ENGINE - DIFFUSER AND COMBUSTION GROUP - NEW INNER NO.4 BEARING AND AIRFRAME MANIFOLD
ASSEMBLY - CATEGORY CODE 8 - MOD.ENG-72-0016

V2500-ENG-72-0016

SERVICE BULLETIN

Location of the Inner No. 4 Bearing And Airframe Manifold Assembly
Fig.1

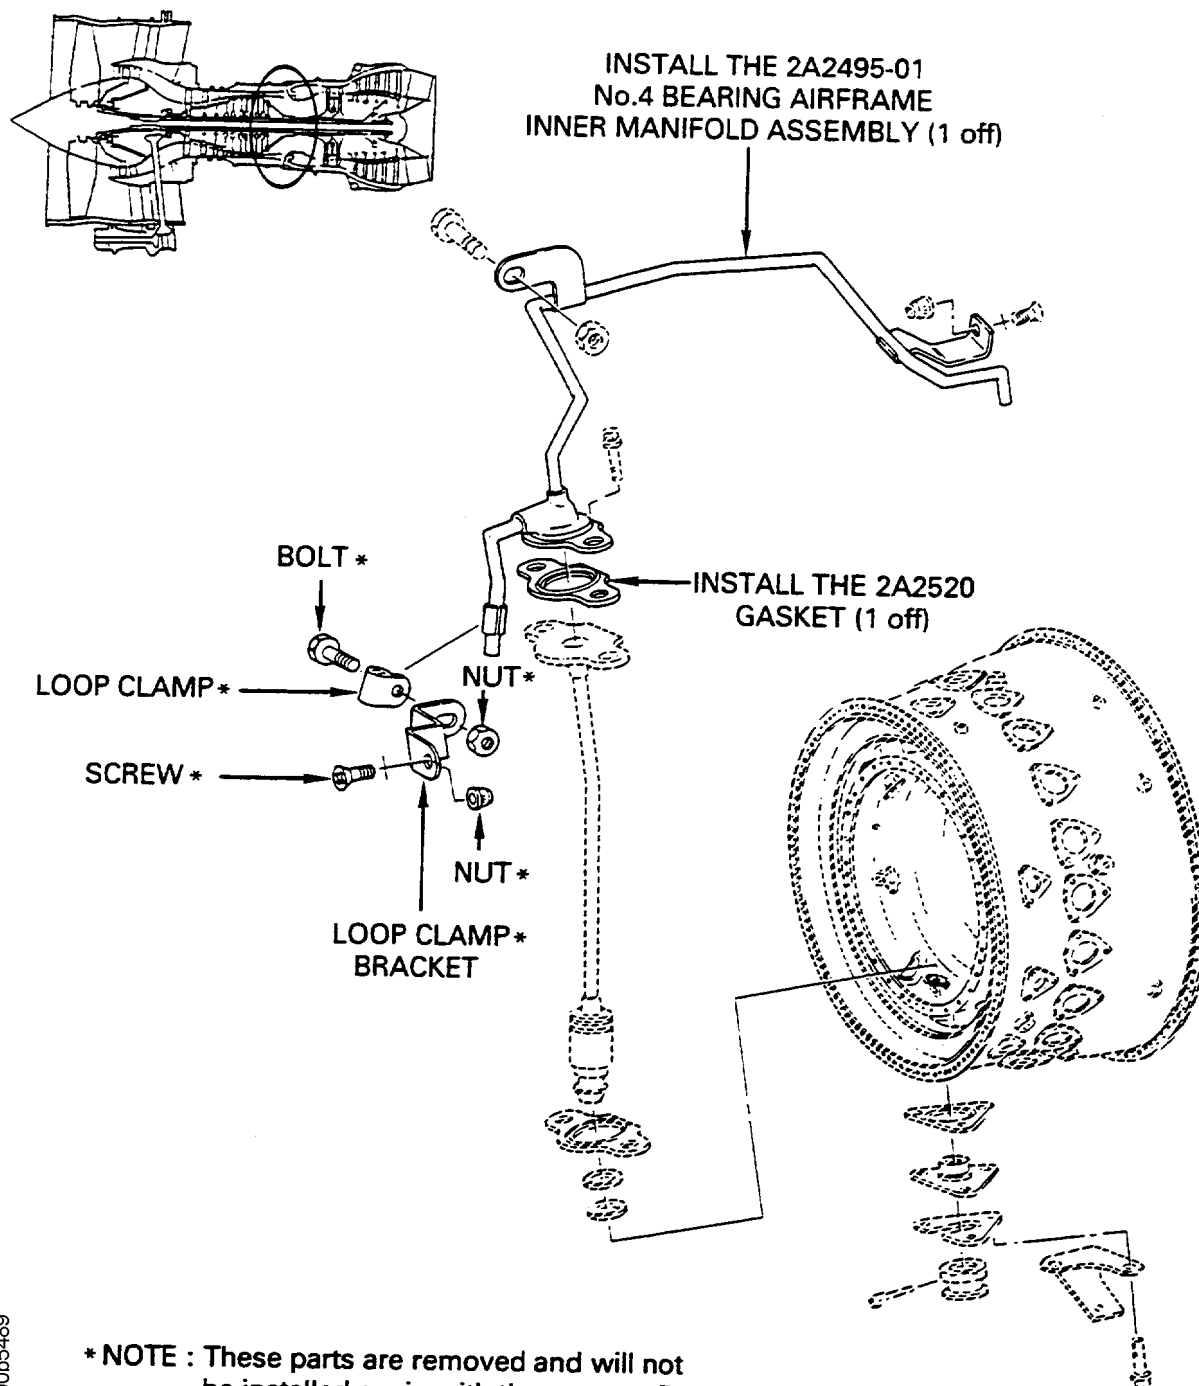
- (1) Provide a new Inner No. 4 Bearing and Airframe Manifold Assembly with a new connector and a revised configuration short tube.
- (2) To remove nuts, brackets, a bolt and a screw which will not be used with the new configuration.

- (1) Install the 2A2496-01 No. 4 Bearing Airframe Inner Manifold Assembly (1 off) by the approved procedure given in Reference (1), Chapter/Section 72-42-00, Assembly, and Figure 1.
 - (a) The parts which follow are not installed with the new configuration: the 2A0489 Loop Clamp bracket (1 off), the MS122902 Loop Clamp (1 off), the MS9489-05 Bolt (1 off), the 4W2326 Screw (1 off), the 493773 Nut (1 off), and the 4W001 Nut (1 off). See Figure 1.
